• **SUSPENSION—TORQUE SPECIFICATIONS—REVISION**

• **NOISE—“CLUNKS”, “KNOCKS” AND “RATTLES”—LOOSE SUSPENSION OR MOTOR MOUNT ATTACHING HARDWARE**

**Article No.
91-4-7**

MERCURY: 1991-1992 CAPRI

Figure 1 - Article 91-4-7

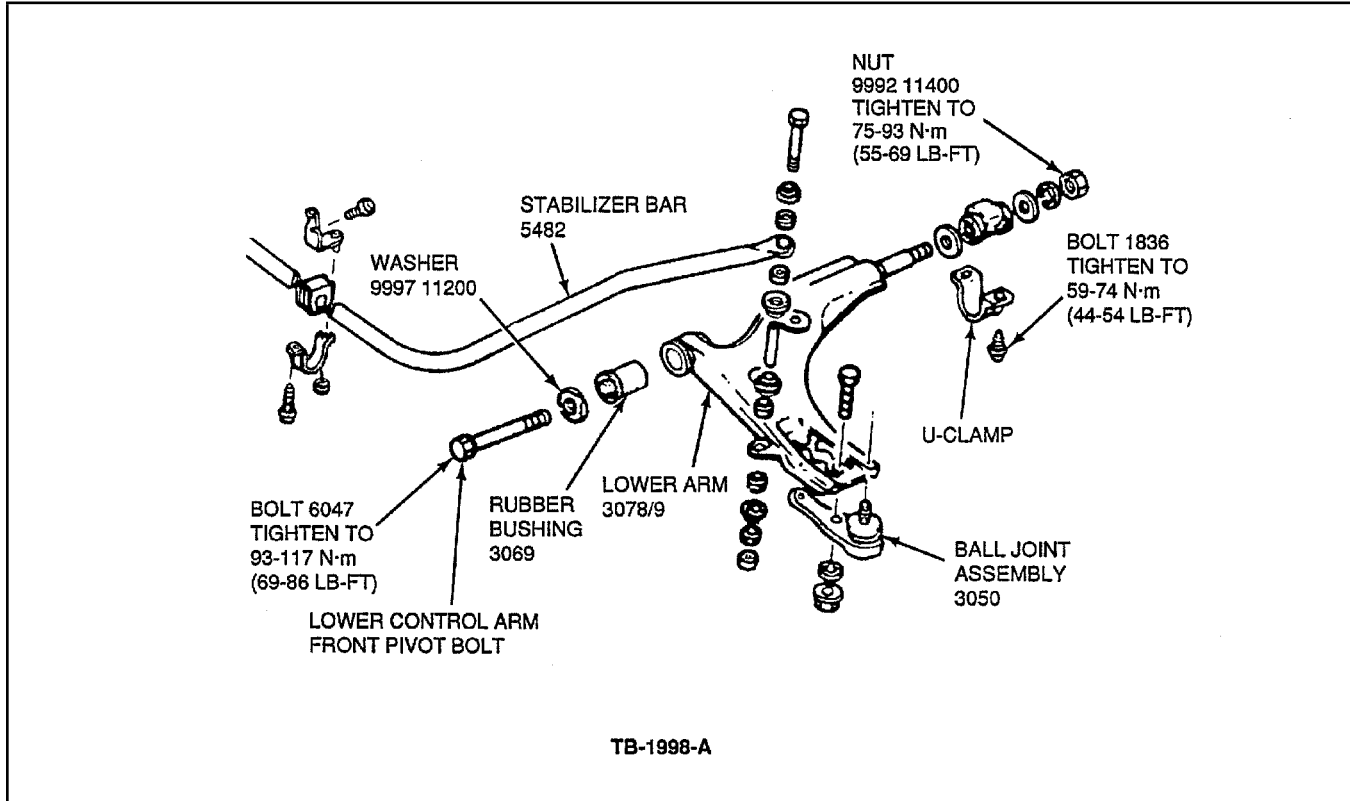
1. Inspect the U-clamps on the lower control arms for the presence of any underbody sealer or tape between the U-clamps and the mounting surface to the underbody, Figure 1.
2. If sealer or tape is present, remove the two bolts holding the clamp and remove the sealer or tape from the area.
3. Re-install the bolts and tighten to 44-54 lb-ft (59-74 N•m).

1. Attempt to tighten the lower control arm front pivot bolt to 55-60 lb-ft (80 N•m), Figure 1.
2. If any movement is noticed, proceed as follows:
 - a. Remove the bolt.
 - b. Clean the threads with a wire brush.
 - c. Apply Threadlock and Sealer (EOAZ-19554-AA).
 - d. Re-install the bolt and tighten to 69-86 lb-ft (93-117 N•m).

Figure 2 - Article 91-4-7

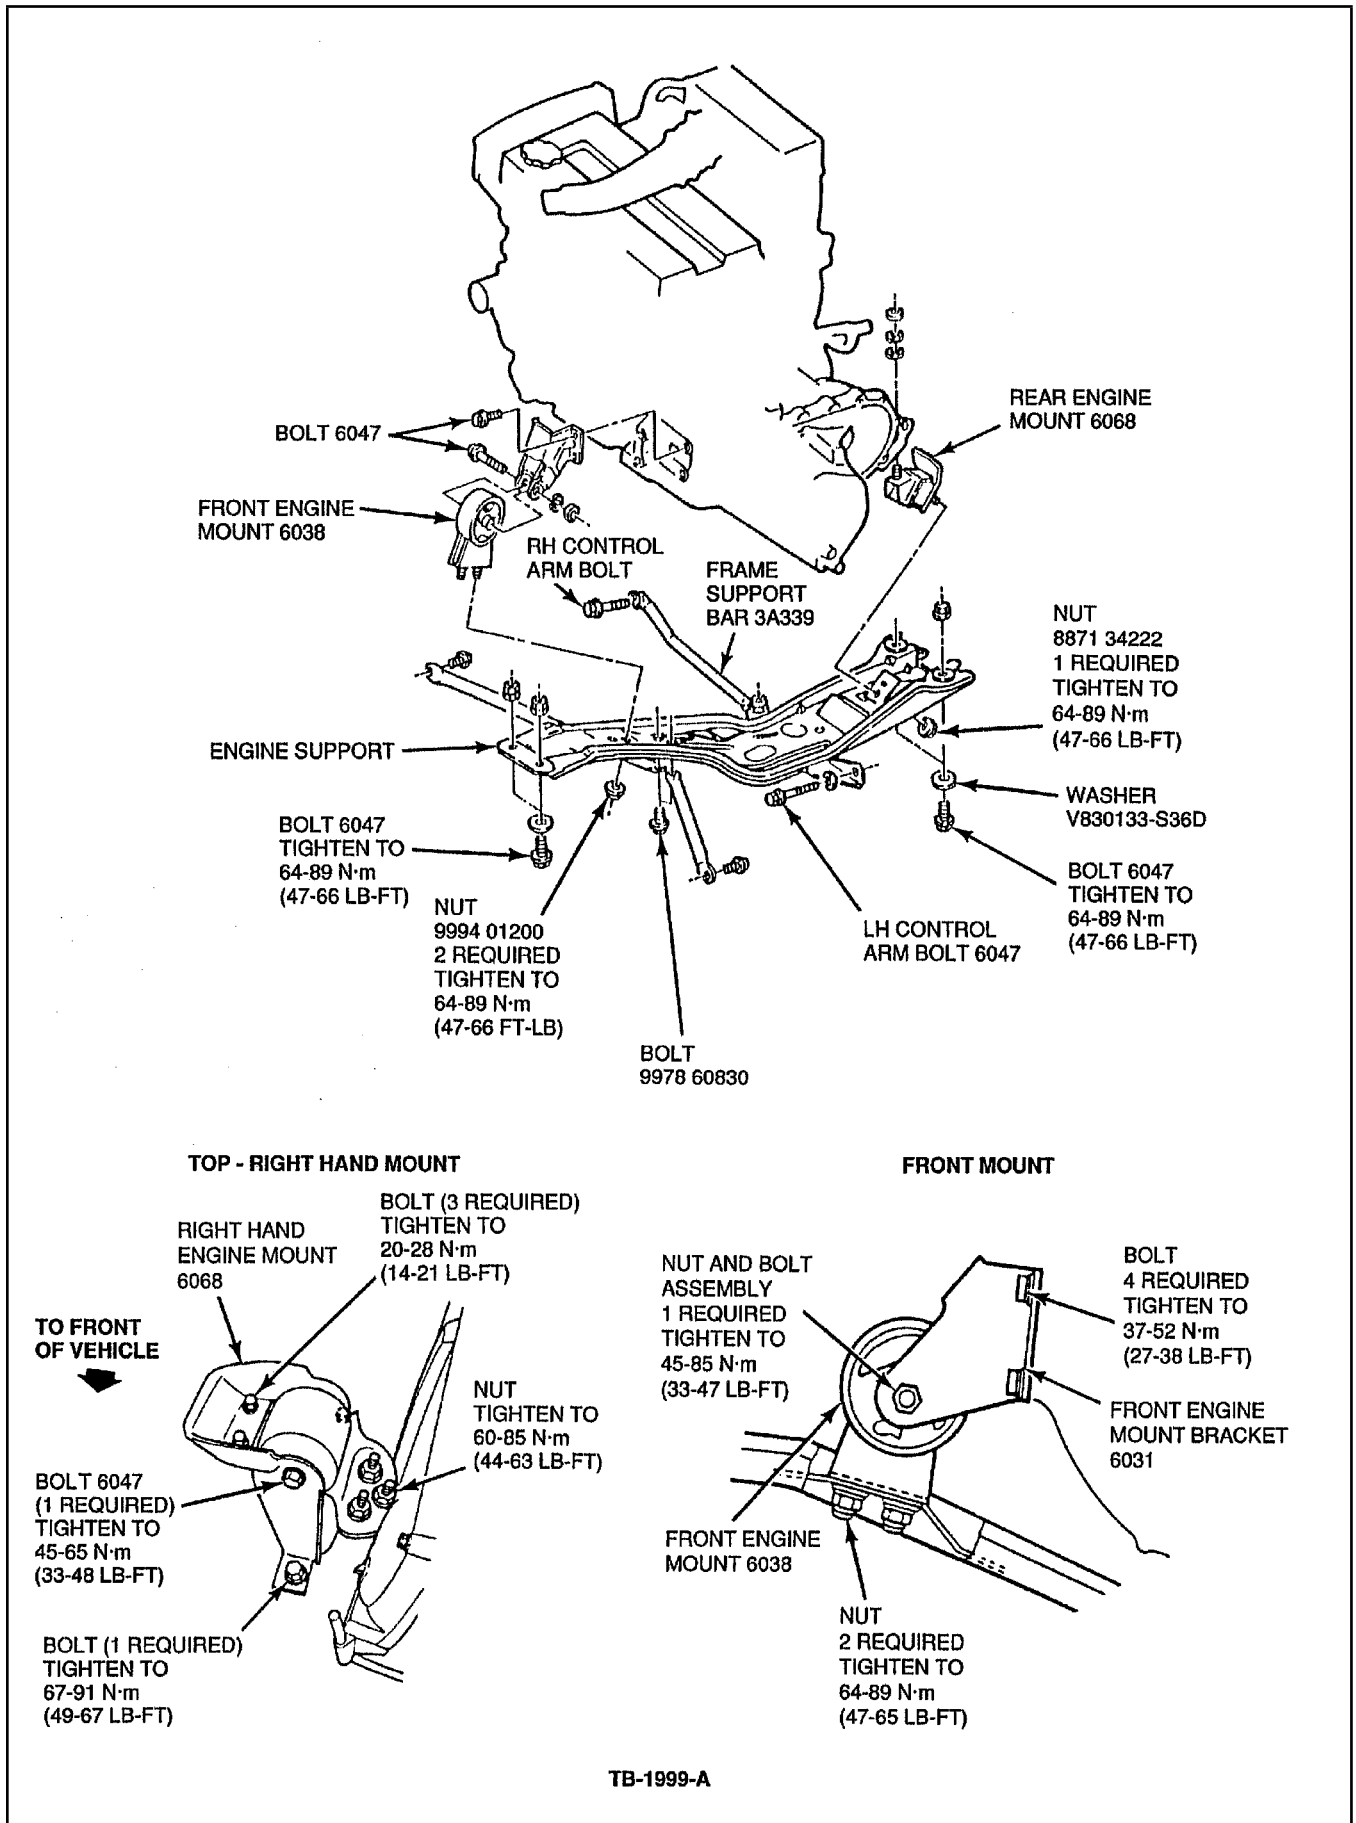
1. Inspect the engine support for the presence of underbody sealer or tape between the engine support and the mounting surface to the underbody, Figure 2.
2. If sealer or tape is present, remove the bolts holding the engine support to the underbody.
3. Remove the sealer or tape from this area.
4. Re-install the bolts and tighten to 47-66 lb-ft (64-89 N•m).
